Proj. No.: SUR2201

Subject: Addendum No. 2
Surf City WWTF Digester/Sludge Holding Tank
Surf City, NC
Owner: Town of Surf City

ADDENDUM NO. 2

FIGURE – STAIRS FOR ITEM 11

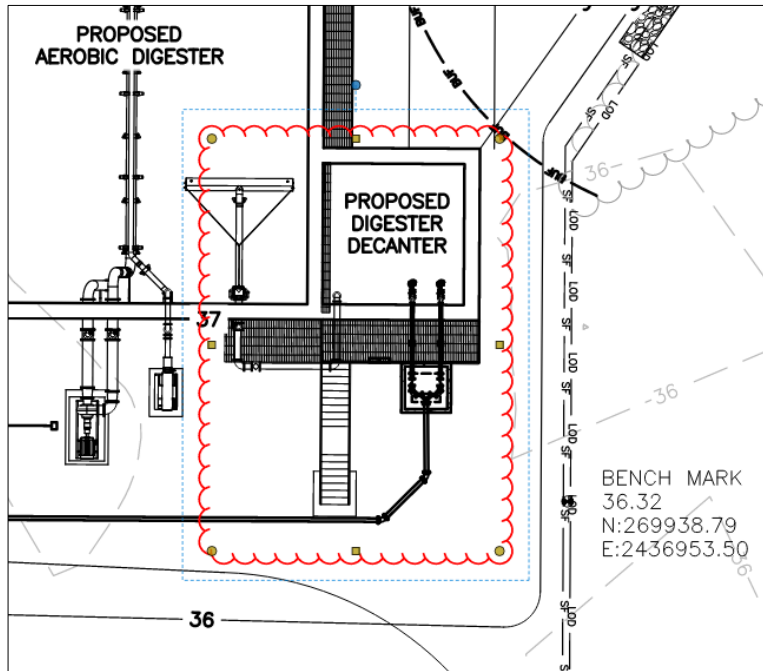
- Item 11. Stairs and Walkways:** Lump sum price to furnish and install new aluminum stairs and walkways associated with the proposed digester decanter. The price shall include all materials including supports, grating, handrails, columns, footings, concrete pads, and chains. Price shall also include concrete supports, testing and incidental items listed in Paragraph B below. See Figure below.

4 TYP. STARTER WALL DETAIL
TYP. N.T.S.

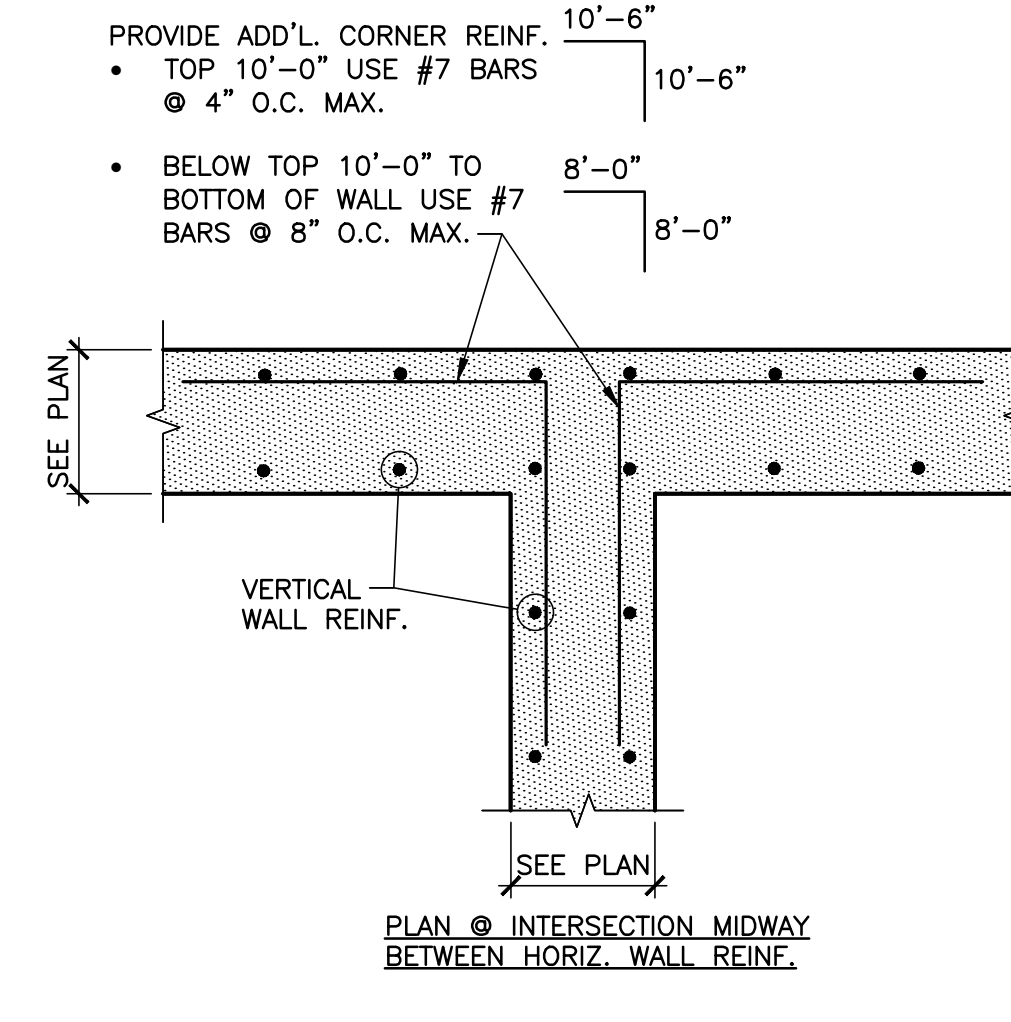
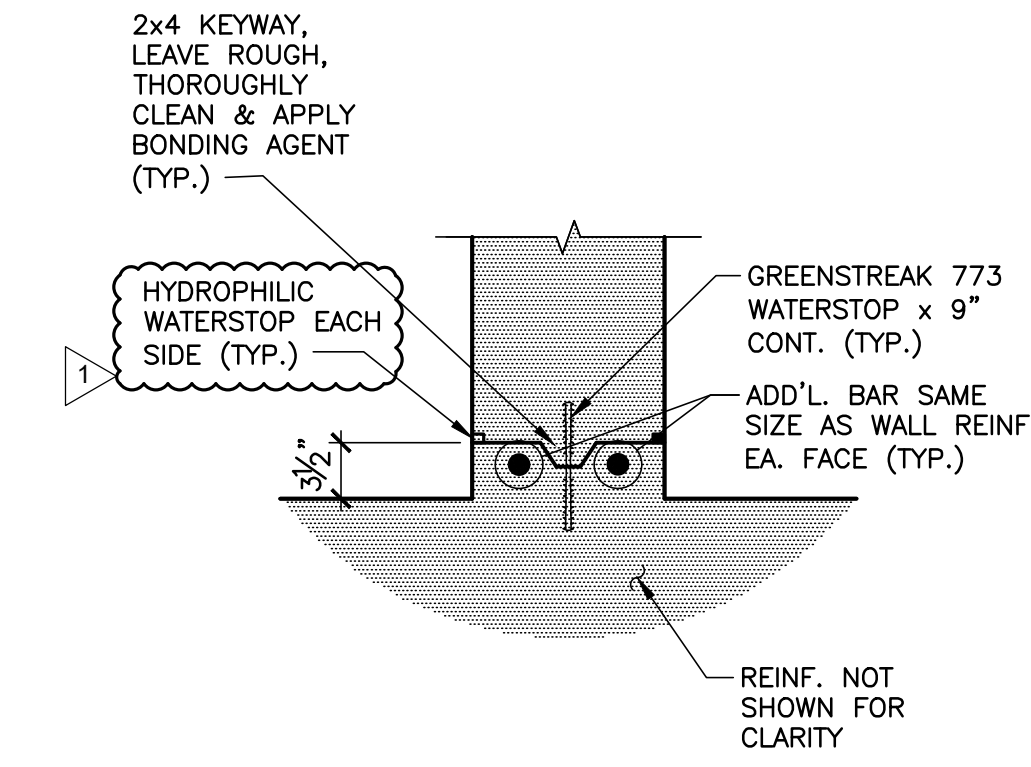
Item 2.25: Can the starter wall (“starter curb”) referenced in Detail 4/S8 be modified to indicate a nominal 4” raised keyway in lieu of a starter wall?

Item 2.31: When looking at A/S6 at the keyway, there are “square” shaped items shown along the keyway. When looking at 4/S8, nothing is shown for these. Please advise what these items are.

A contractor-requested modification to the starter wall will be reviewed by the EOR if requested by the contractor, subs or the formwork engineer. The modification above may be considered if all parties agree to the change.

Refer to Sheet S8 – Cast-in-Place Concrete Details and replace with the attached.

1 STAIR & WALKWAY FRAMING PLAN
S9 SCALE: 3/8" = 1'-0"

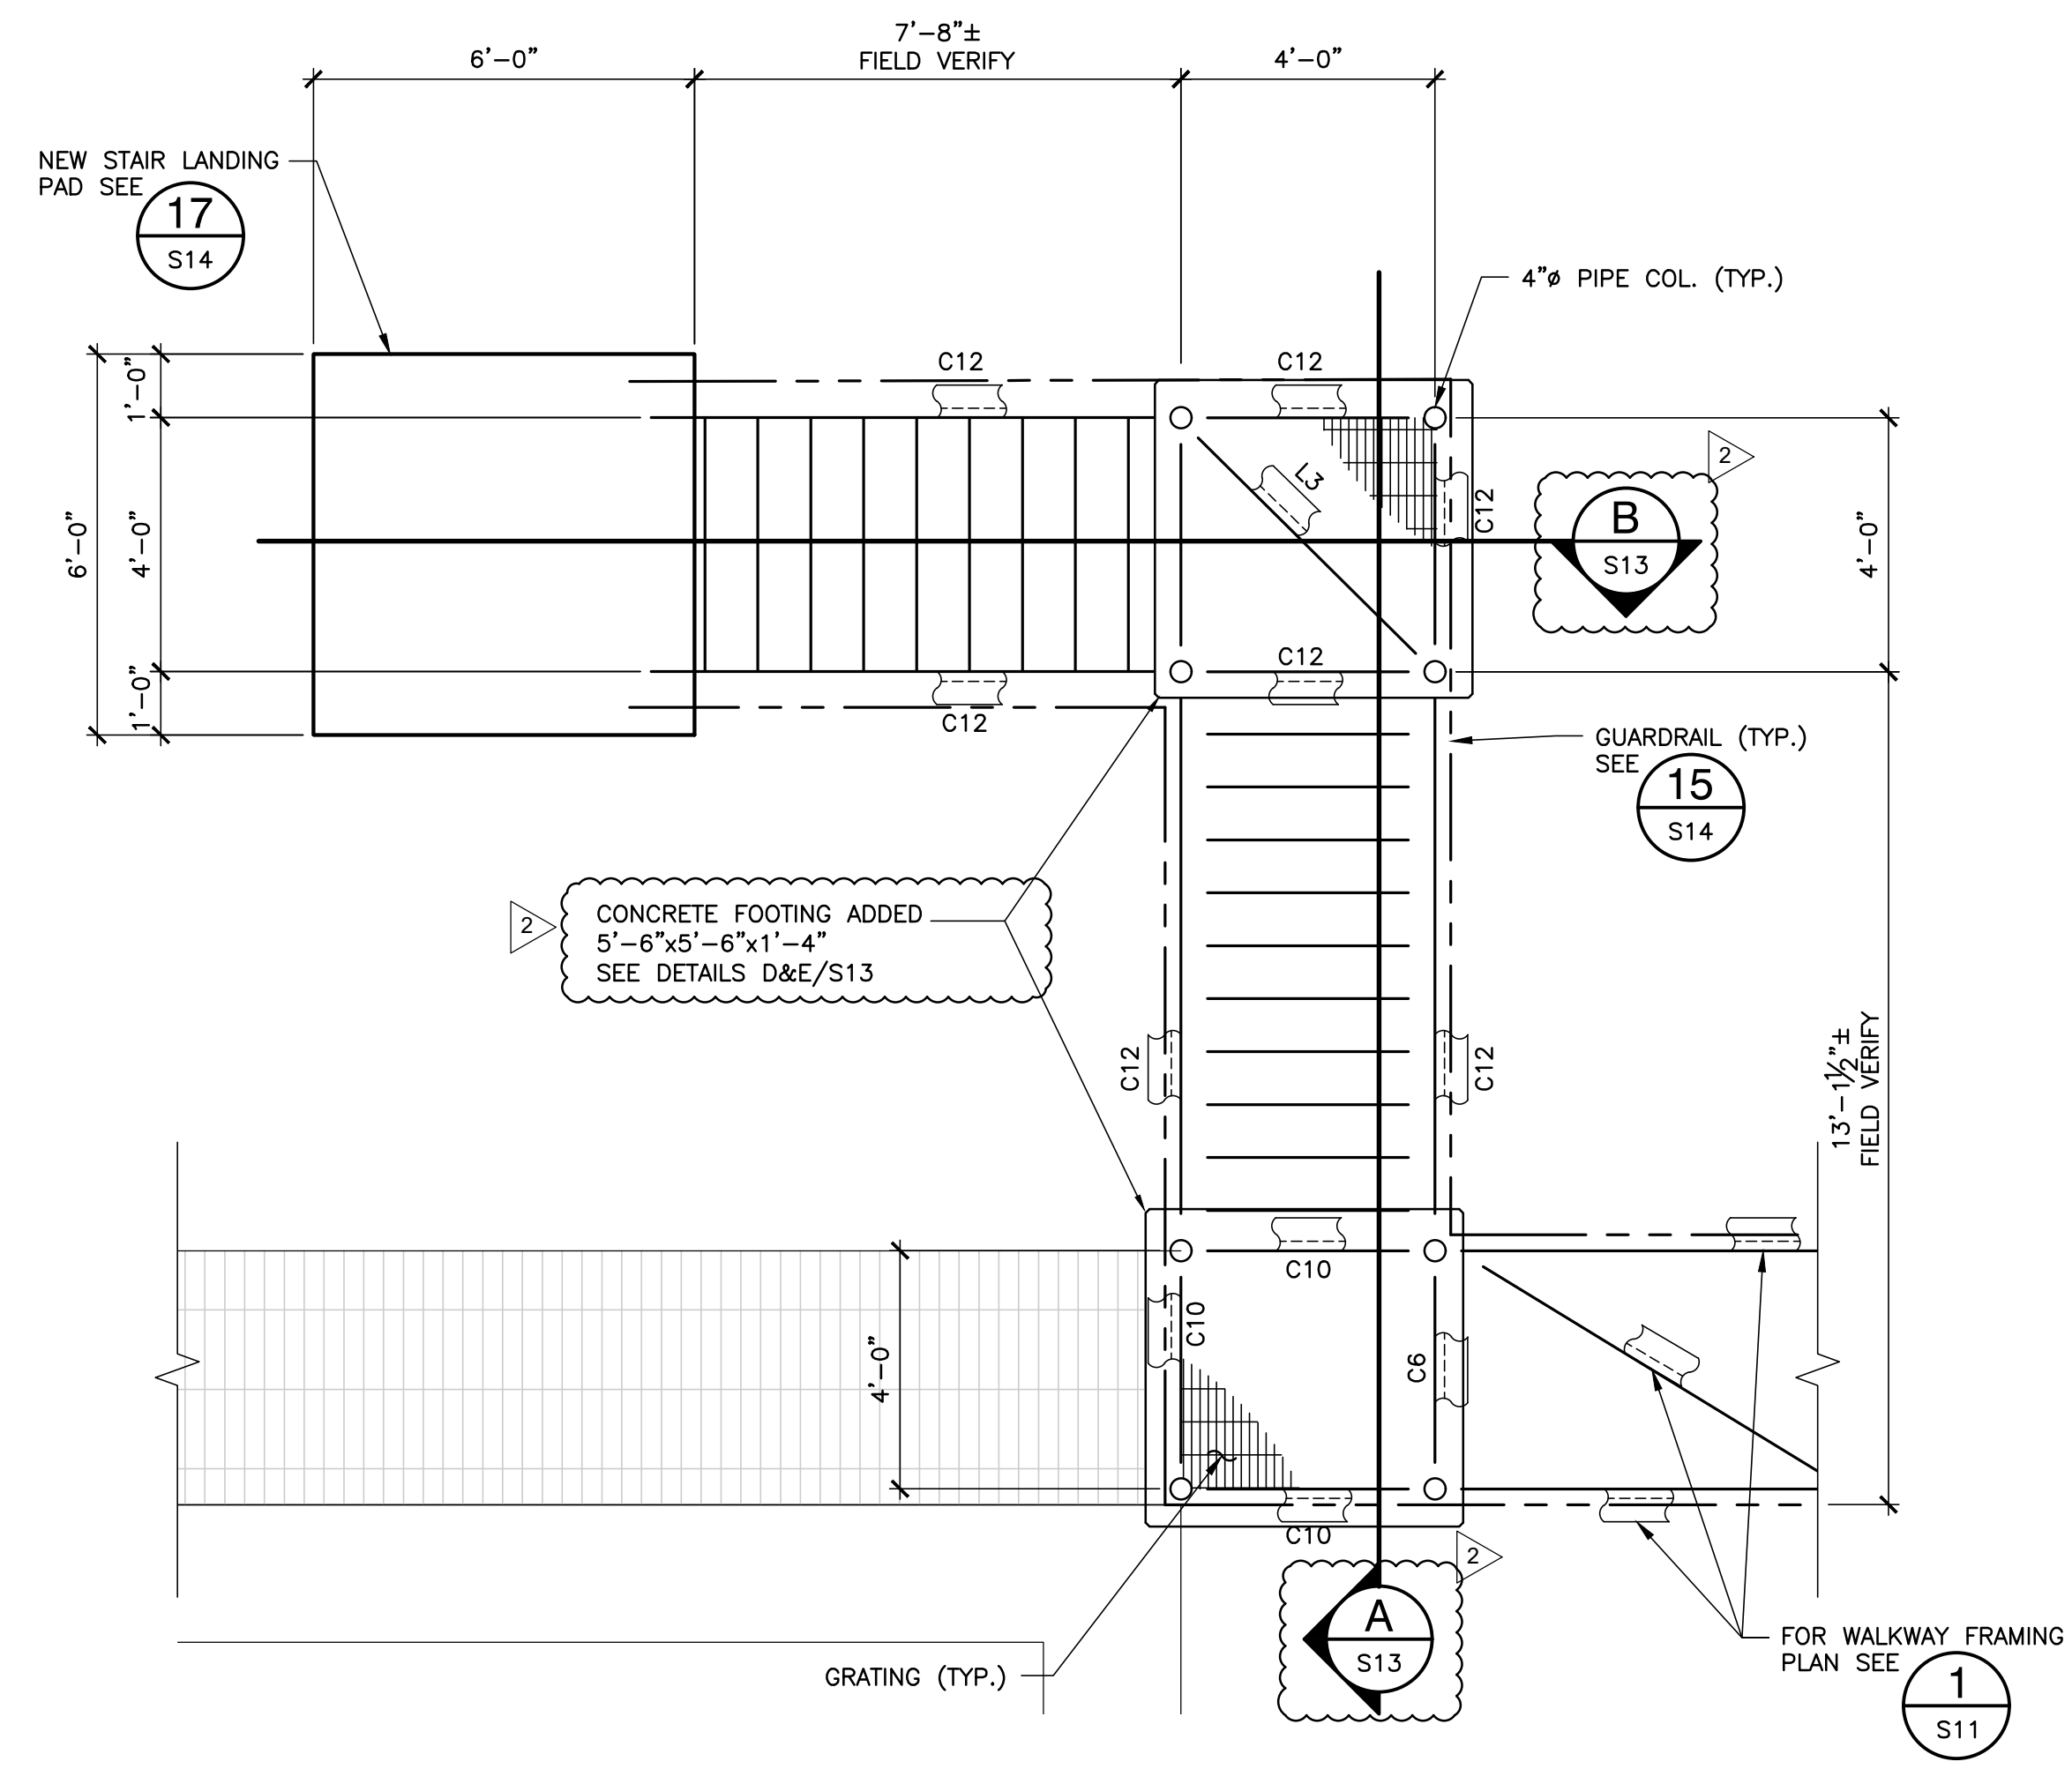
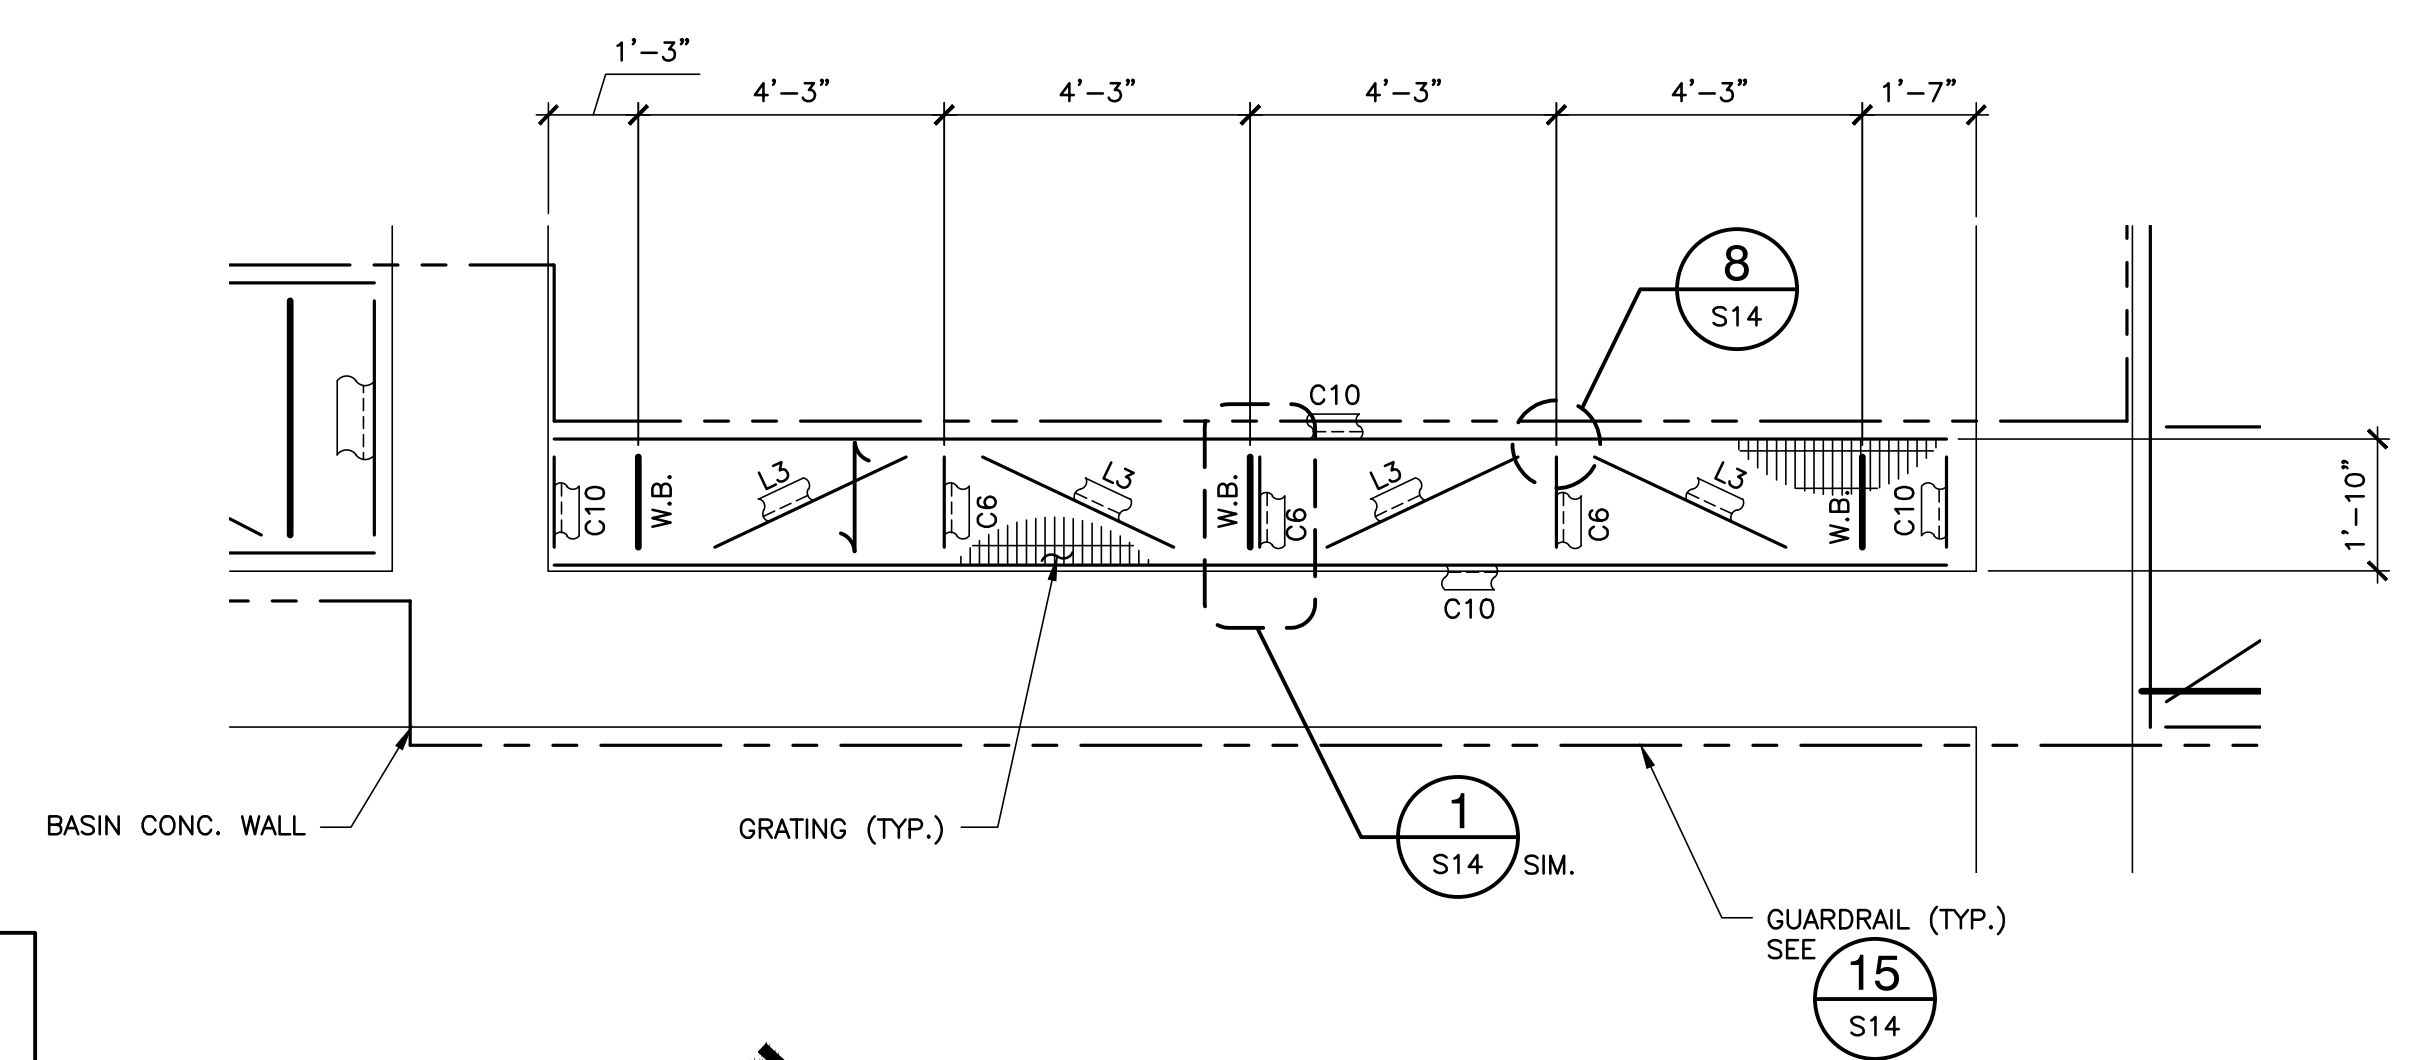
Item 2.27: The proposed walkways and stair modifications shown on Drawing C-1.1 at the existing Aerobic Digester will conflict with an existing concrete pilaster. Please advise.

Extend landing four feet to clear pilaster and adjust stairs, piping and equipment placement accordingly. Revisions will be included in the issued for construction drawings.
